Re: WDMCS 2025 Valley Stadium Roofing Replacements
West Des Moines Community Schools
4440 Mills Civic Pkwy
West Des Moines, Iowa 50265

ADDENDUM #2

September 29th, 2025

SECTION DETAIL - COPING CAP FLASHING @ MACHINE ROOM

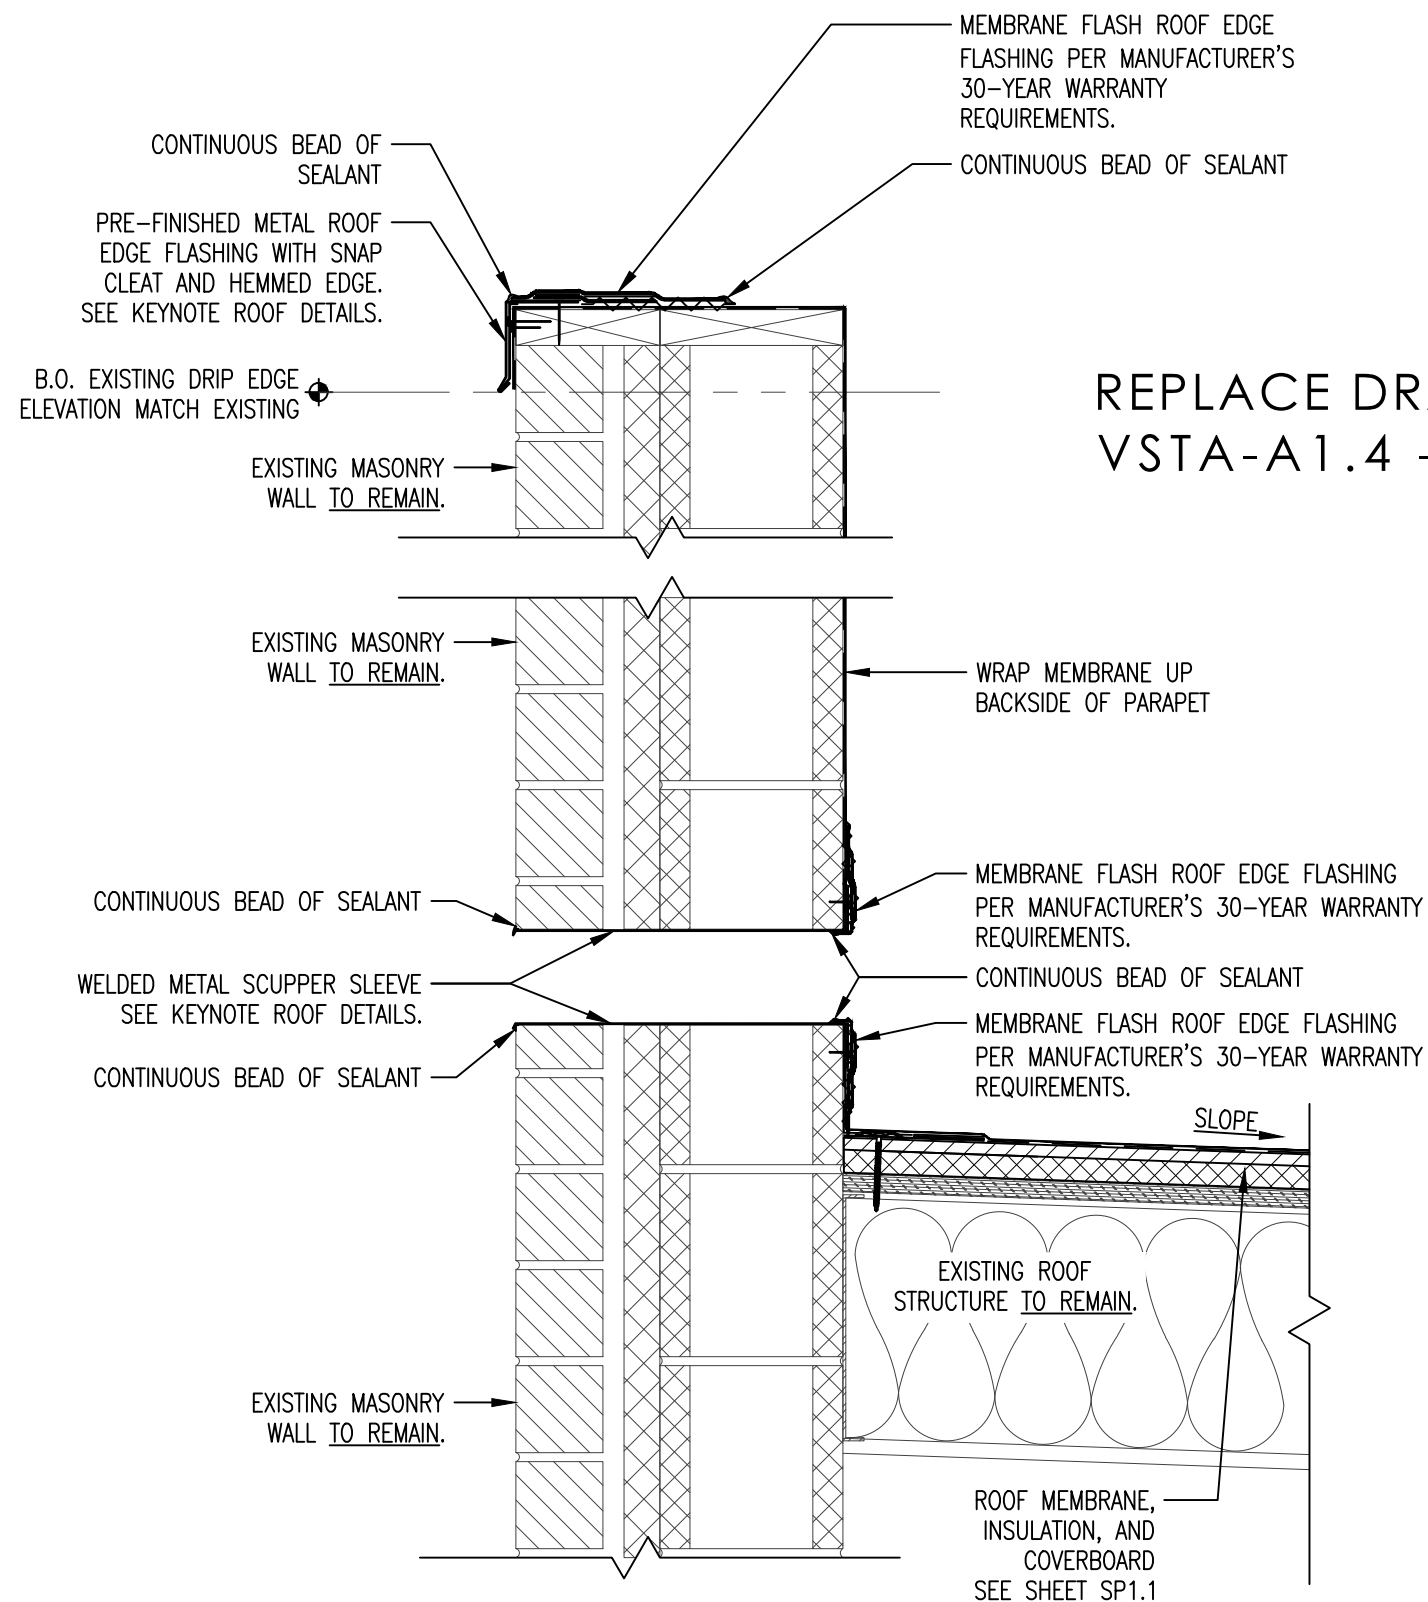
Item #A2: **REVISION – COPING CAP AT ROOF AREA ‘C’**

At roof area ‘C’ on drawing #1 on sheet VSTA-A1.1 – ROOF PLAN, provide roof edge fascia flashing in lieu of coping cap.

Replace all keynote #7 with keynote #6. In addition to providing roof edge fascia flashing, wrap the roof membrane up backside and over top of parapet. Adhere to backside of parapet.

See attached supplemental drawing showing revised detail #4 on sheet VSTA-A1.4 – ROOF DETAILS.

REPLACE DRAWING #4 ON SHEET
VSTA-A1.4 - ROOFING DETAILS
